Appendix E Water Quality Opportunities Memorandum (McGowan Consulting LLC)

To: Prem Kumar, City Engineer
From: Kathleen McGowan and Susan Robinson
Subject: Review of 2021 Storm Drain Master Plan for Water Quality Improvement Opportunities
Date: June 2, 2021
Link: [Certified Full Capture System List of Trash Treatment Control Devices \(Updated February 2021\)](#)

This memo summarizes our focused review of the City of Manhattan Beach (City) 2021 Storm Drain Master Plan dated February 2021 (90% complete) targeting identified opportunities for stormwater quality mitigation and protection.

To: Stephanie Katsouleas, Public Works Director and Shawn Igoe, Utilities Division Manager
From: Susan Robinson and Kathleen McGowan
Subject: Strand Stormwater Collection Sumps
Date: June 10, 2020
Attachments:

Map 3 Strand Drainage System Configuration: Collection Basin #6 and Sump #7

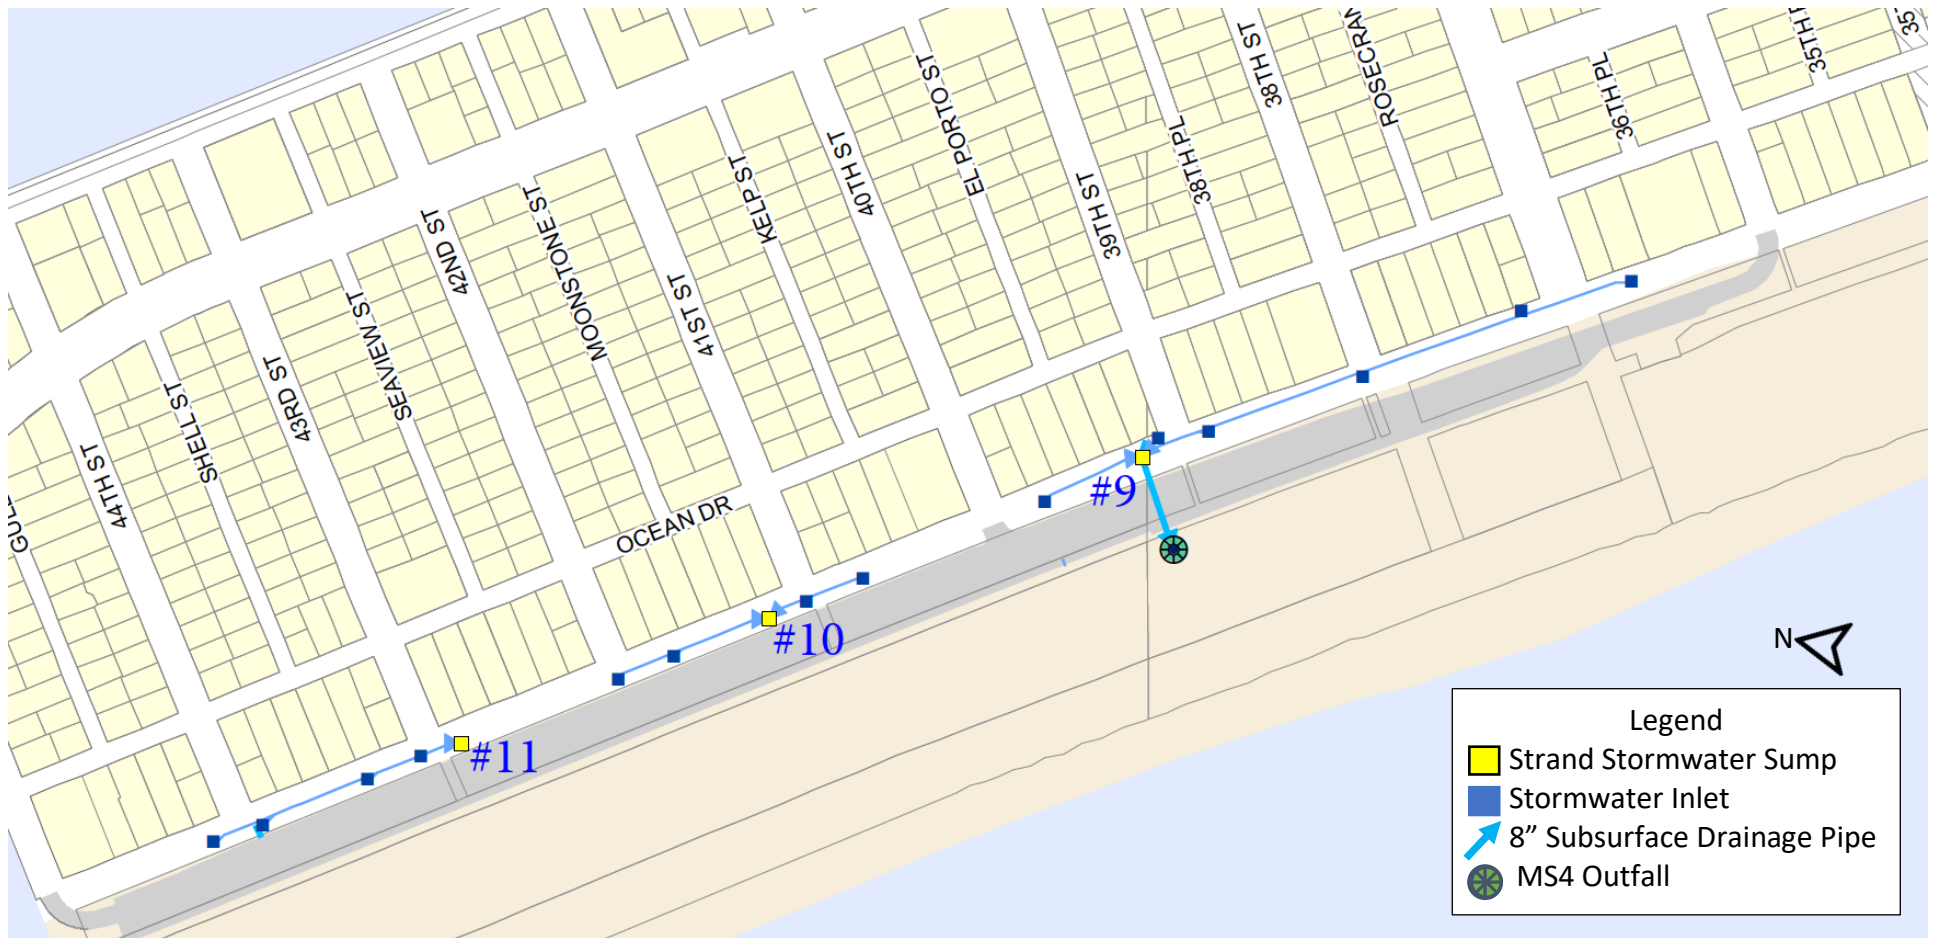
1. Collection Basin #6 at 17th Place: We were unable to open this unit, however the Wastewater Supervisor confirmed that Public Works staff had connected it into the MS4 outfall that discharges just west of the dunes at the terminus of 18th Street.
2. Collection Basin #9 at 39th Street: It was determined based on visual observation of a connector pipe in the back wall of this sump (shown in the enclosed photo of Basin #9 with a blue arrow denoting the connector pipe) that this unit is "Case A" and is connected to the MS4 outfall located at the terminus of 39th Street.

The remaining two (2) collection basins, #6 and #9, are connected to the MS4 system. These two collection basins will therefore require retrofit with 5-mm screens designed to prevent the discharge of trash from the volume of runoff from their tributary areas generated during the 1-year, 1-hour storm event in order to be certified as full-capture devices⁷:

The retrofit of Basins #6 and #9 should be completed no later than March 20, 2021 which is the City's deadline for completing retrofits of 100% of its MS4 system outside the tributary area to planned Regional Stormwater projects, i.e., outside the tributary area to the 28th Street Storm Drain system. This updated approach will be reported to the Regional Board in the City's Annual Stormwater Report for FY1920 that is due December 15, 2020.
